Mazda Motor Corporation

Category F	Technical	Ref. No. E016/06	Page 1 of 1
Coverage <input type="checkbox"/> Distributor only <input checked="" type="checkbox"/> Please inform your dealers		Date Issued July 5, 2006	
Please convey this information to your <input type="checkbox"/> Director <input checked="" type="checkbox"/> General Manager <input checked="" type="checkbox"/> Warranty Dept. <input checked="" type="checkbox"/> Parts Dept. <input checked="" type="checkbox"/> Training Dept. <input checked="" type="checkbox"/> Field Rep.		Attachment Attachment 3 pages	
Applicable Model RX-8 (FE / SE)		Applicable Countries or Specifications Worldwide

Subject: Parts Supersession Between Ventilation Kit, Oil Level Gauge and Oil Level Gauge Tube

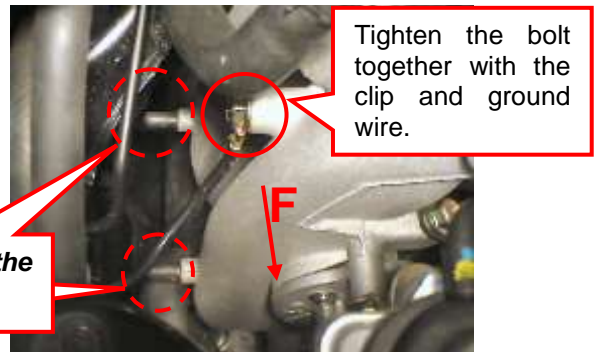
1. Remove the engine cover and battery cover, then disconnect the negative cable from the battery.
2. Disconnect the air hose.
3. Remove the throttle body. (Do not disconnect the water hose.)
4. Remove the extension manifold (upper).
As for high-power vehicle, loosen the bolts 1 – 5, and nuts 6 and 7, then remove the extension manifold (upper) from the vehicle.

As for standard power vehicle, loosen the bolts 1 – 3, and nuts 6 and 7.

5. Replace the oil filler pipe ass'y of the extension manifold (upper) with a modified one.
Note: At this stage, the two bolts do not need to be tightened completely, but just place them. These will be tightened when the extension manifold is installed later.
6. Replace the gaskets on the extension manifold (upper), with modified ones. (4 gaskets on standard power vehicle, and 5 gaskets on the high-power vehicle)
7. Reinstall the extension manifold (upper) in the reverse order of removal.
Note 1: When installing the solenoid valves, pay special attention to the connector color of each solenoid valve and the layout of vacuum hose.
Note 2: Prior to tightening the bolts and nuts, be sure to adjust the position properly.

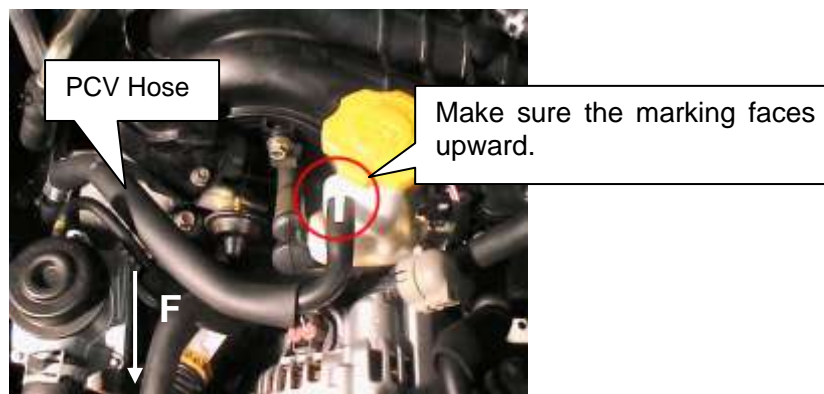
10. Install a PCV hose in the extension manifold (upper).
Note: Make sure that the marking on the PCV hose comes to the top.

11. Secure the PCV hose with a clip.
Note: Make sure that the marking is not hidden.

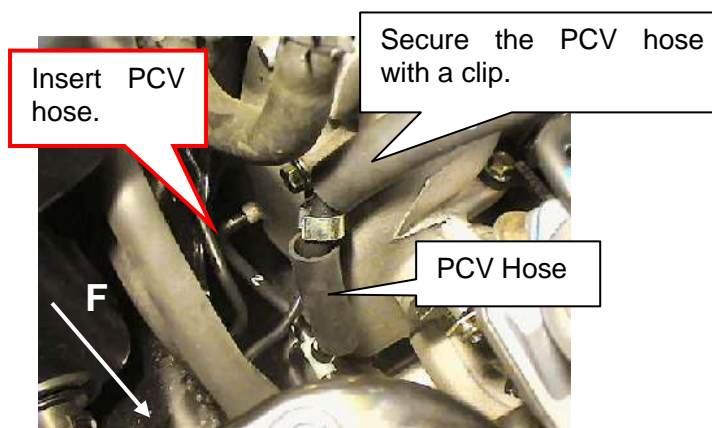
12. Insert the PCV hose into the two boost pipes.

13. Replace the vacuum tube of the air hose with a modified one.
Note: Discard the replaced vacuum tube.

14. Install the air hose in the throttle body.

15. Insert a pipe in to the vacuum tube of the air hose.

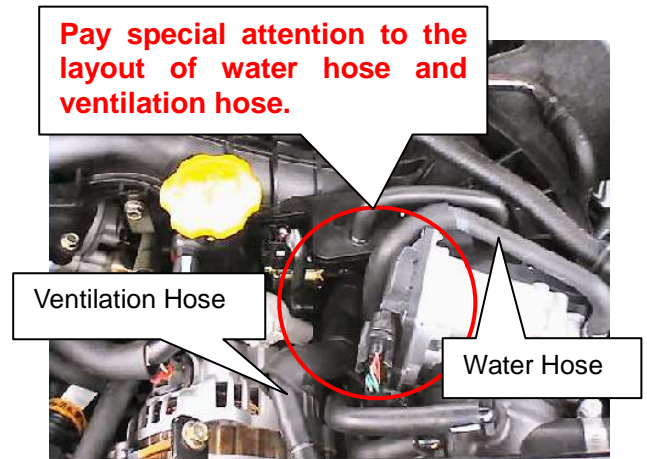
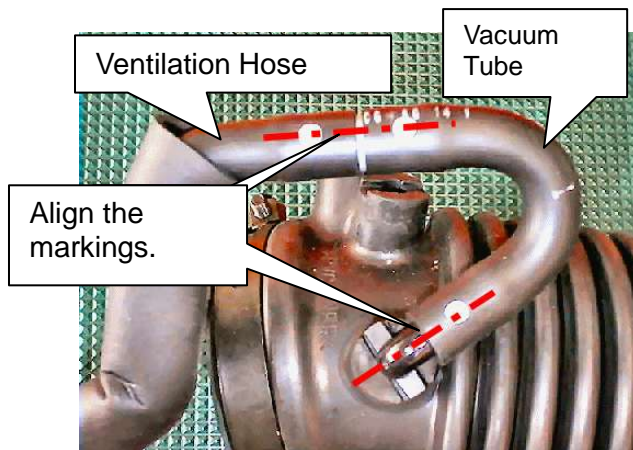
16. Assemble the vacuum tube of air hose with the modified ventilation hose.
Note 1: Align the markings of vacuum tube, ventilation hose and air hose.
Note 2: When installing the ventilation hose, make sure that the water hose should be positioned under the ventilation hose.
